NEDO-24011-A, Revision 21,
General Electric Standard Application for Reactor Fuel
(GESTAR II, U.S. Supplement), May 2015

**General Electric Standard Application
for Reactor Fuel**

(Supplement for United States)

**Figure S-2. Loss-of-Coolant Accident Evaluation Model
(SAFER/GESTR Analysis Methods)**

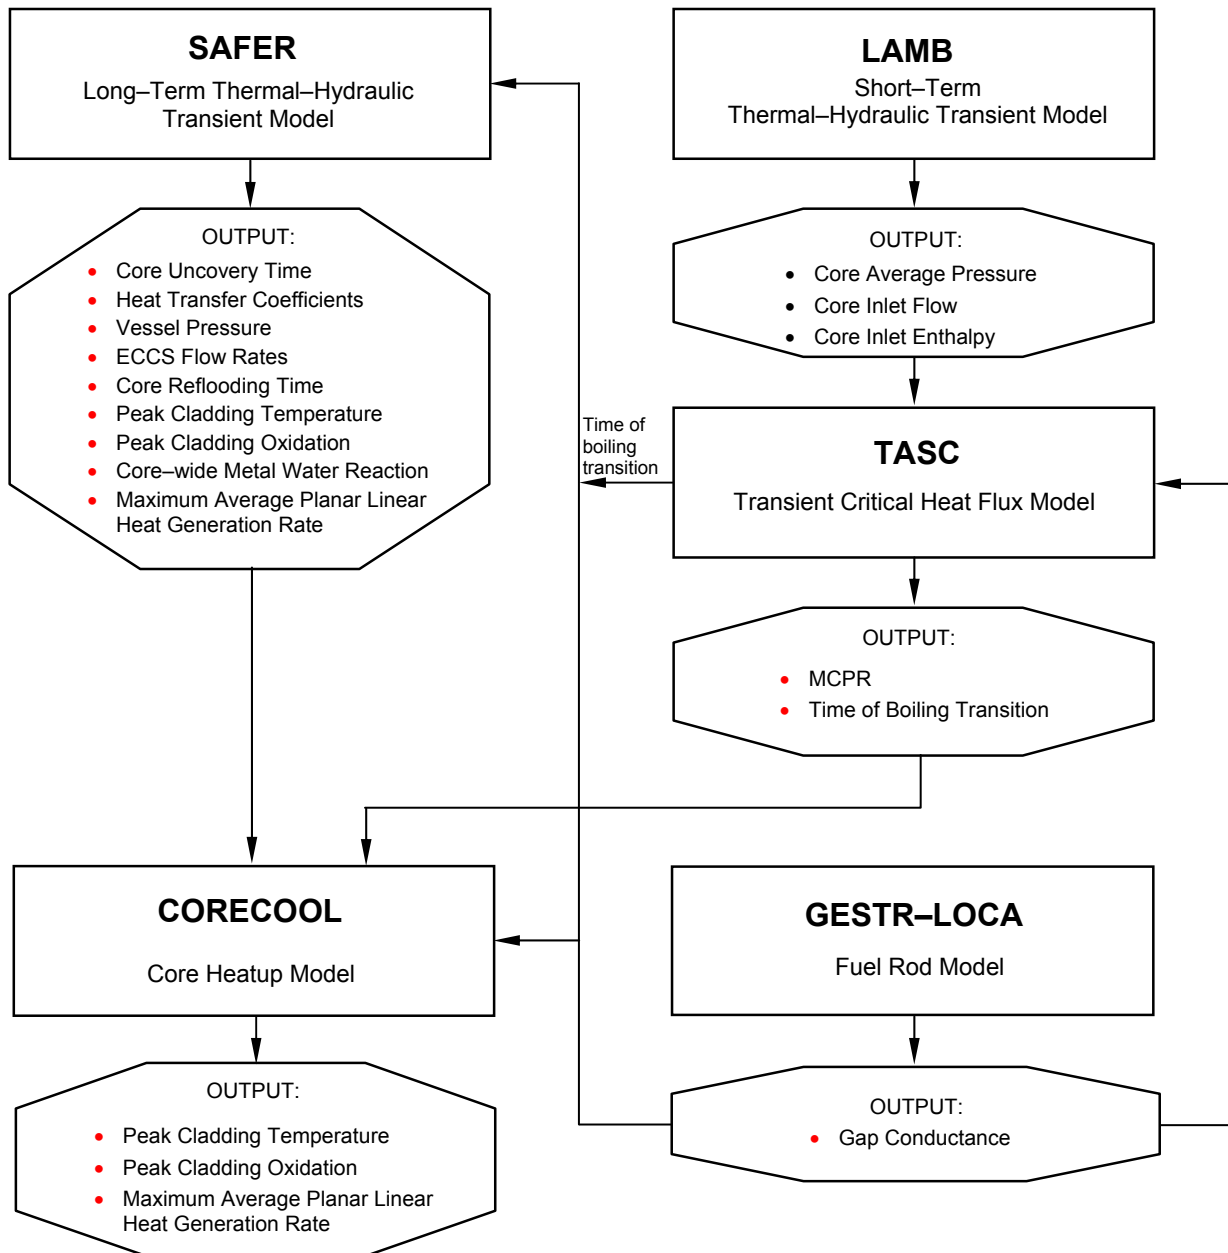
Correct Error in Figure S-2, "Loss-of-Coolant Accident Evaluation Model (SAFER/GESTR Analysis Methods)"

This figure has been updated to reflect the use of CORECOOL code instead of CHASTE for the core heatup model. The use of CORECOOL was approved in NEDC-30996P-A. This LTR has been previously reviewed and approved. The staff agrees that changing this reference in Figure S-2 is an administrative change and therefore is acceptable to the staff.

Figure S-6. Scenario 2 Krypton Whole Body Dose with Respect to Charcoal Hold Up

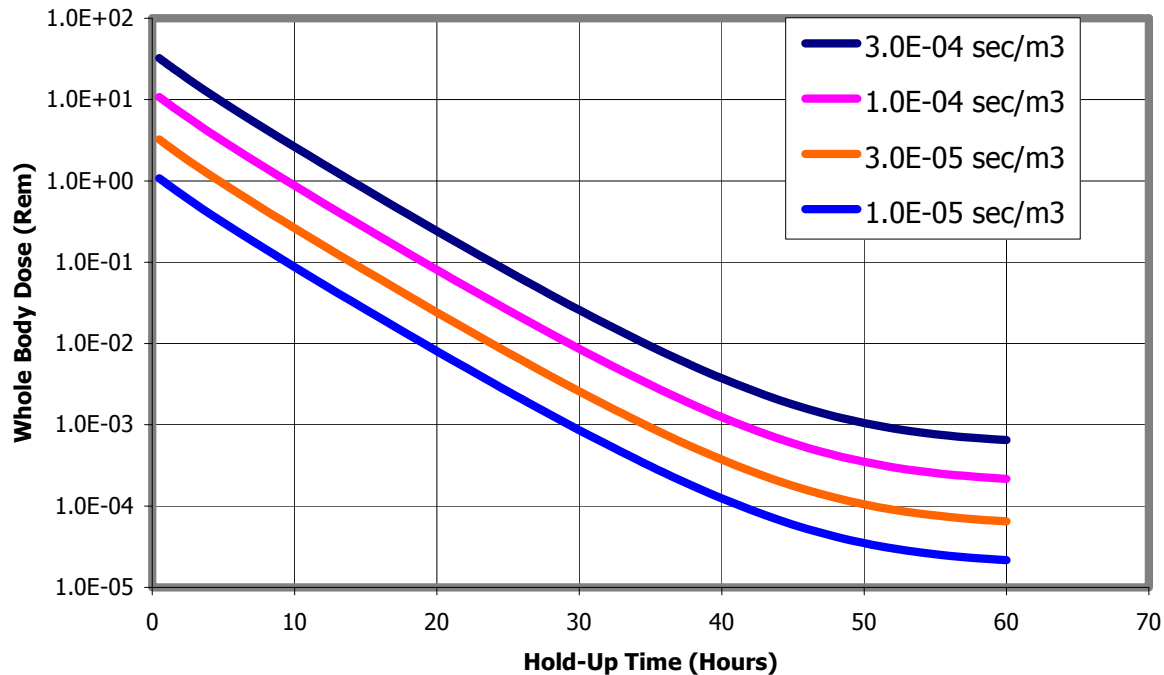
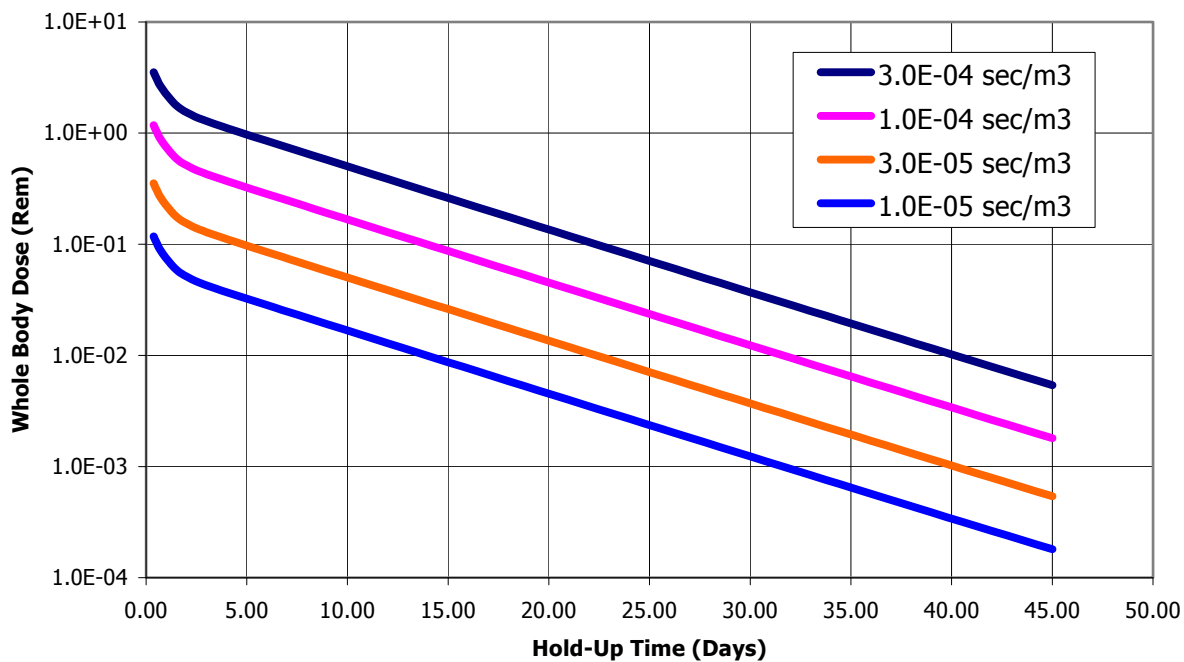
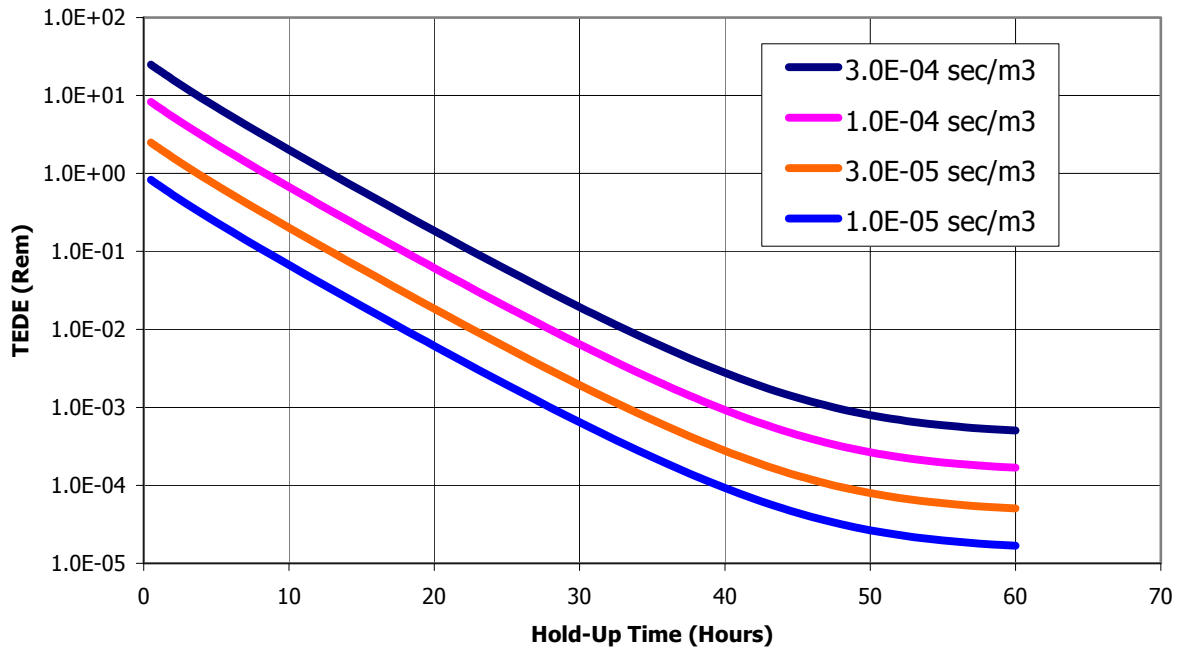
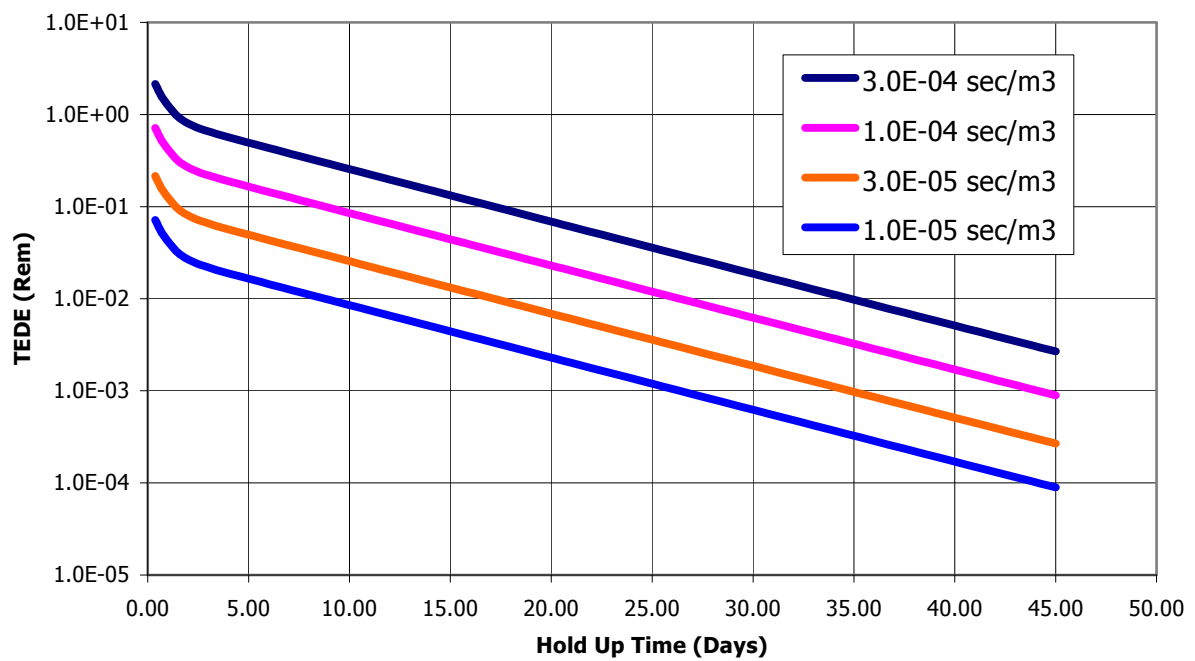
- For accident Scenario 2, please provide the amount of fission products released from the offgas system, resulting doses, and relevant dose calculations for several representative charcoal holdup times in Figures B-2, B-3, B-5, and B-6 of Attachment B.

A sample calculation is provided to show how the curves in Attachment B Figures B-2 and B-3 were generated. The dose conversion factors that were used are as follows:

The resulting Kr whole body dose for a X/Q of 1.0E-04 sec/m³ and an offgas holdup time of 40 hours is 1.24E-03 Rem, which is consistent with the applicable curve in Attachment B Figure B-2.

The resulting Xe whole body dose for a X/Q of $3.0\text{E-}04 \text{ sec/m}^3$ and an offgas holdup time of 40 days is $1.02\text{E-}02 \text{ Rem}$, which is consistent with the applicable curve in Attachment B Figure B-3.

The resulting Kr TEDE dose for a X/Q of 1.0E-04 sec/m³ and an offgas holdup time of 40 hours is 9.24E-04 Rem, which is consistent with the applicable curve in Attachment B Figure B-5.

The resulting Xe TEDE dose for a X/Q of 3.0E-04 sec/m³ and an offgas holdup time of 35 days is 9.75E-03 Rem, which is consistent with the applicable curve in Attachment B Figure B-6.

Figure 5.2-1. Effects of Initial MCPR on Δ CPR Typical BWR Core

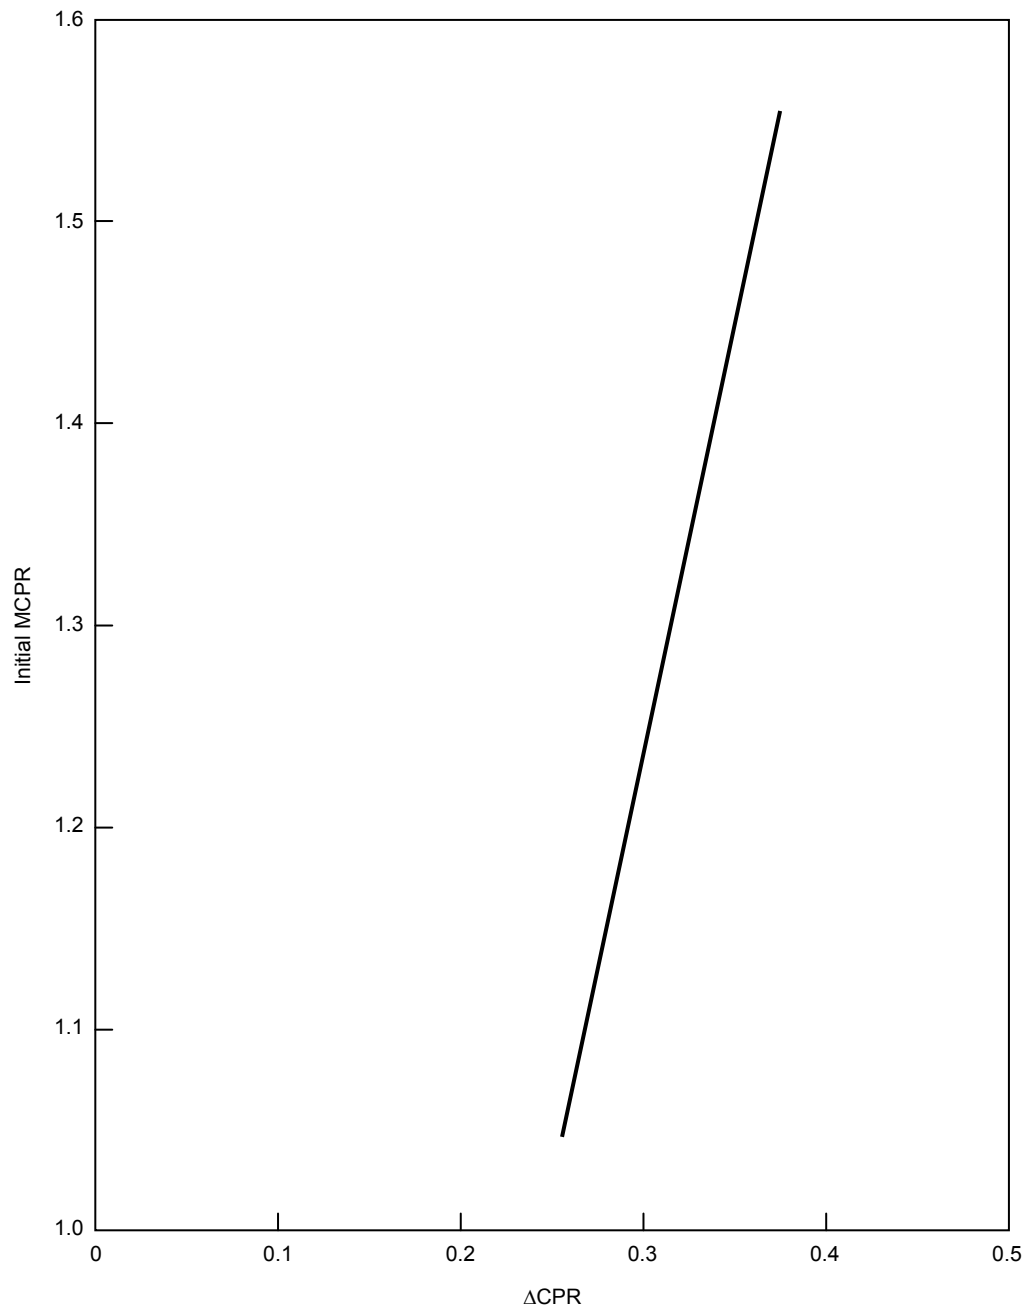
Based on Figure 5.2-1 in Appendix B on page US-6 under S.2.2.1, it appears that the change in ΔCPR versus initial MCPR may be 0.1 versus 0.5 not .01 versus 0.05. Please clarify that the statement is still valid when the change in ΔCPR is approximately 0.01 for 0.05 change in initial MCPR based on Figure 5.2-1 in Appendix B.

Figure 5.2-1 and the associated text in Appendix B of GESTAR II was generated to address an RAI on GESTAR II, Revision 5.

The specific response addressed the transient ΔCPR process and the initial MCPR assumption. Figure 5.2-1 and the discussion in GESTAR show the relative insensitivity of the ΔCPR to the initial MCPR assumption. This figure does indicate approximately a 0.01 change in ΔCPR for a 0.05 change in initial MCPR. The transient analysis process iterates the hot bundle power to achieve an initial MCPR such that the minimum CPR during the transient reaches the SLMCPR. In other words, the limiting transient could start at the OLMCPR and the minimum CPR would be the SLMCPR. Transients that are less severe have lower ΔCPR s, therefore, the initial MCPR in the transient needs to be lower for the transient minimum to reach the SLMCPR. The main point of the original response is to describe that starting non-limiting transients at a lower initial MCPR is acceptable because of the small impact to the ΔCPR . A non-limiting transient can begin the transient at a CPR less than the OLMCPR and have a minimum CPR above the SLMCPR.

Figure 5.2-3. K_f Factor

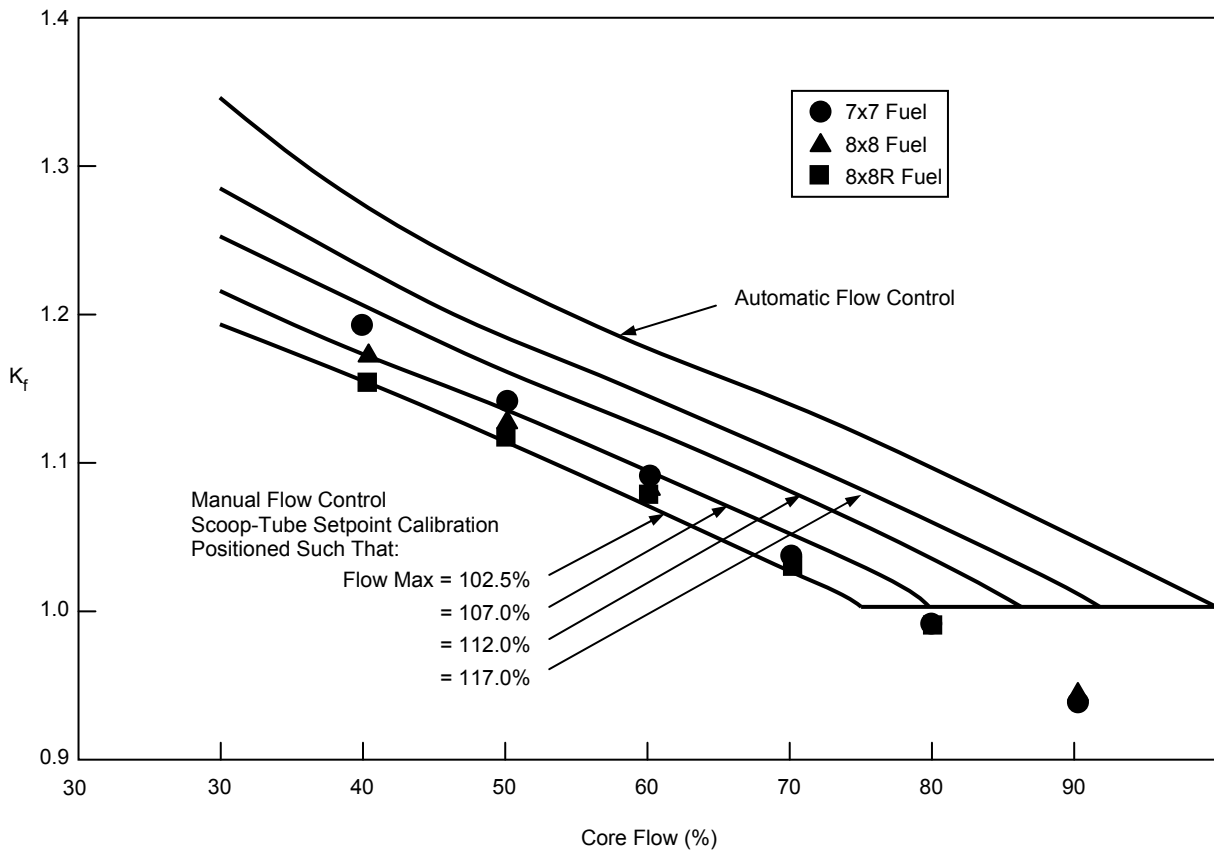
The brief paragraphs, which discuss the operating limit MCPR/low flow correction curves, K_F , for reduced core flow conditions, do not adequately describe the basis for the construction of the generic curves shown in Figure 5-7. A substantially more detailed discussion of the procedure employed is required. Describe the models, methods and assumptions used, which make the curves generic for BWR/2, BWR/3 and BWR/4 plants incorporating up to three different fuel designs. Either justify why the new fuel design (8x8R) is conservatively bounded by the analysis or provide an additional thermal hydraulic analysis to demonstrate that the indicated curves are bounding. Clearly state the criteria used for developing the curves for the automatic and manual flow control modes.

Figure 5.2-3 compares the derived 102.5% core flow K_f curve with the standard curves (Figure 5-7). These results show that the 8x8R fuel closely follows the 102.5% line, but the 7x7 fuel is 3.3% nonconservative at 40% core flow. However, the K_f curves are conservative for all cores with 7x7 operating limits greater than 1.23.

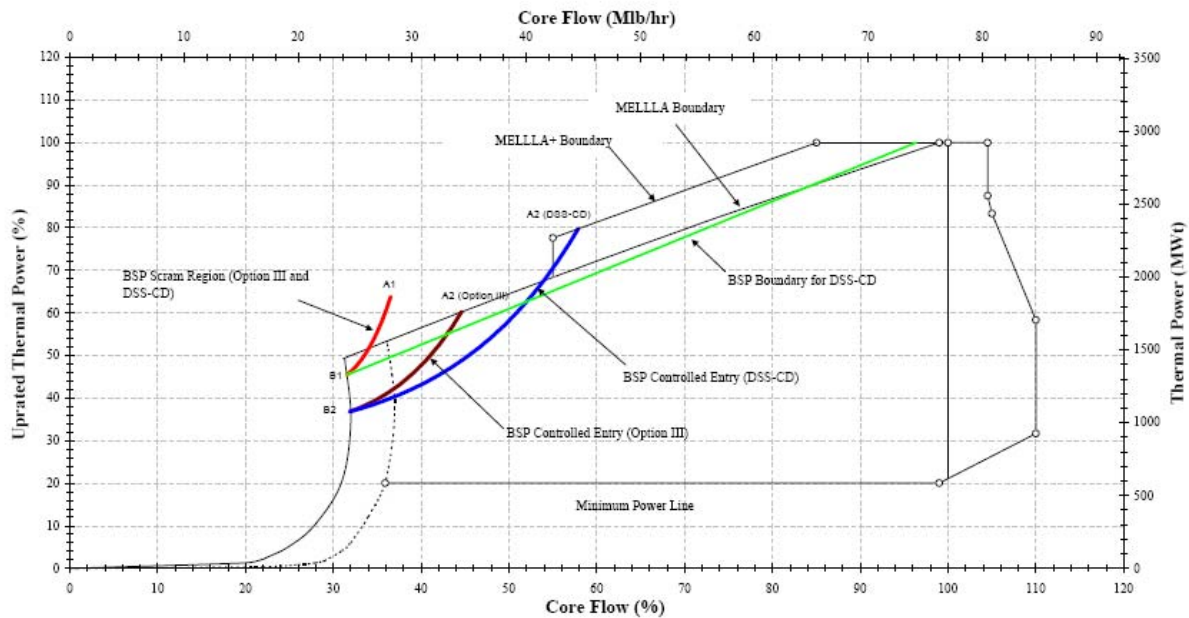
Please provide a power/flow map to show the difference of the domain for Backup Stability Protection (BSP) for DSS-CD under S.4.2.3 and Backup Stability Protection (BSP) for Option III under S.4.2.2, and describe what role Reference S-103 plays to generate a defined exclusion regions.

The calculated stability region boundaries for BSP for DSS-CD and BSP for Option III are shown in the figure below. Please note that the actual implemented BSP boundaries might be larger due to the Base BSP region definitions.
